C 00 S P L # 99111	C 01 S 57.2.2 P 190 L 5 # 561
Bharati, Barnali Wipro Technologies	Brown, Benjamin AMCC
Comment Type E Comment Status A D1.1 #171 Please use either on/off or true/flase consistantly, rather than using all of them for the same variable. Difference Difference	Comment Type E Comment Status A This reference needs to be added to Clause 1.3 SuggestedRemedy
SuggestedRemedy	Add this reference to Clause 1.3
Proposed Response Response Status C ACCEPT IN PRINCIPLE.	Proposed Response Response Status C ACCEPT IN PRINCIPLE.
Please provide specific instances and we will correct them.	Reassigning comment to Clause 1. Add reference for "ITU-T Recommendation G.975" to 1.3
C 00 S 21 P L # 266 Dawe, Piers Agilent	C 04 S 0 P 0 L 0 # 522 Brown, Benjamin AMCC

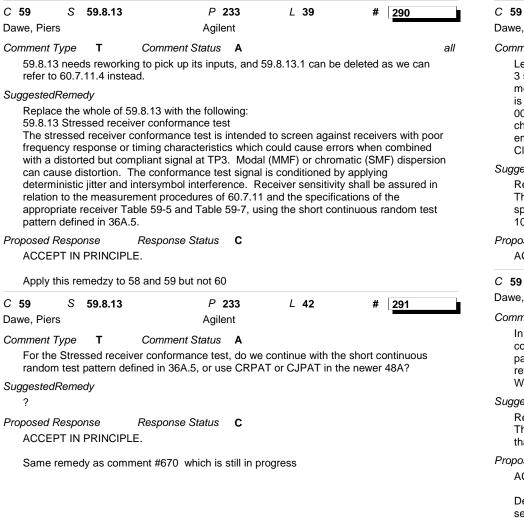
Change the rise/fall time spec from 0.26 ns to 300 ps or 0.30 ns. Insert the spaces in (max,20-80%response time). Change the Average launch power on MMF from -11.5 to -11.0 dBm.					
				Proposed Response Response Status C ACCEPT.					
				C 59 S 59.3.1 P 225 L 28 # 285 Dawe, Piers Agilent

Comment Type T Comment Status A Wish to simplify the use of sensitive receivers and to move towards consistency across different PMD types which could be connected to the same fibres. To do that we should be stricter about power leakage from an 'off' transmitter. We are talking about newly built transceivers here, not old parts.					
				SuggestedRemedy					
				Change -30 to -45 here and in table 59-6.					
				Proposed Response Response Status C
